Re: **2020 Water Master Plan (dated March 2022) (PR#67-2022)**  
**Pacific City Joint Water-Sanitation Authority (PWS ID#00609)**  
**Concurrence with Master Plan**

This letter is regarding the *2020 Water System Master Plan* (“Master Plan”) dated March 2022 for the Pacific City Joint Water-Sanitation Authority (PCJWSA, PWS ID #4100609) received by our office on April 8, 2022. A plan review fee of \$4,125 was also received on April 8, 2022. We have assigned plan review number 67-2022 ([PR #67-2022](#)) for this review.

Figure 5-5. Tsunami Inundation Zone

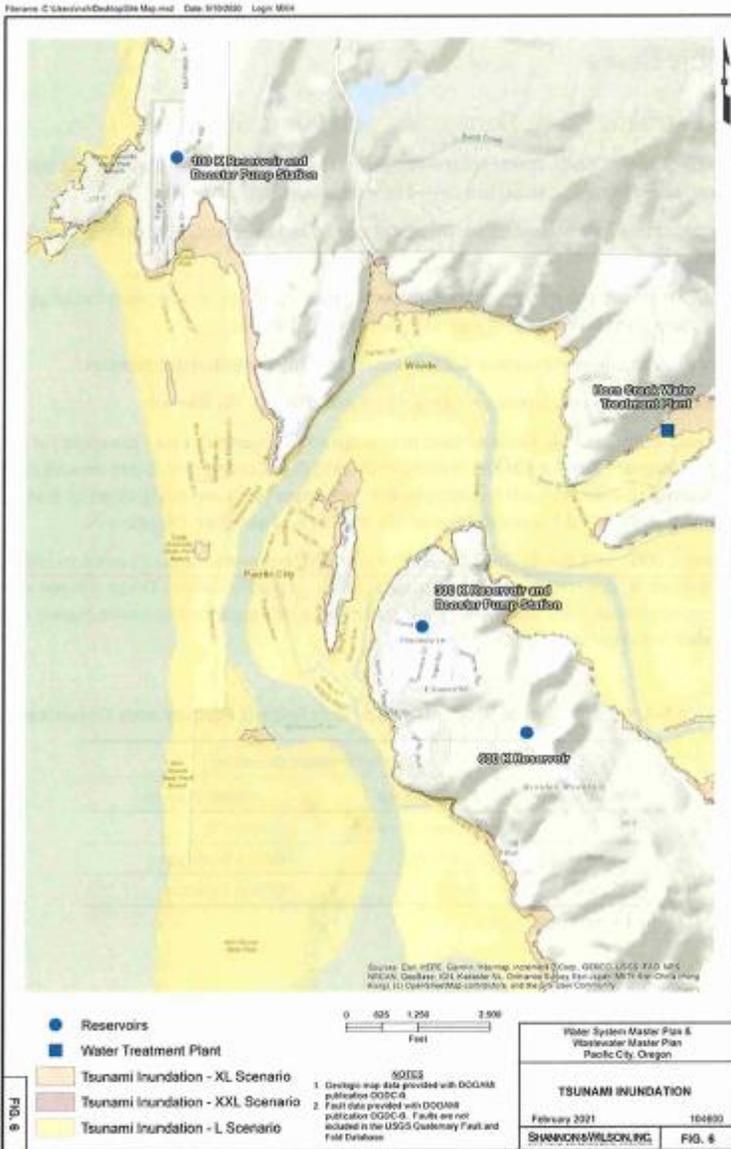
3. Since the Horn Creek treatment plant is located in the Tsunami inundation zone for a Cascadia Subduction Zone (CSZ) seismic event, it may be worth looking into moving critical records and backup/redundant computer systems/files/controls to an off-site location away from Tsunami and other seismic hazards.
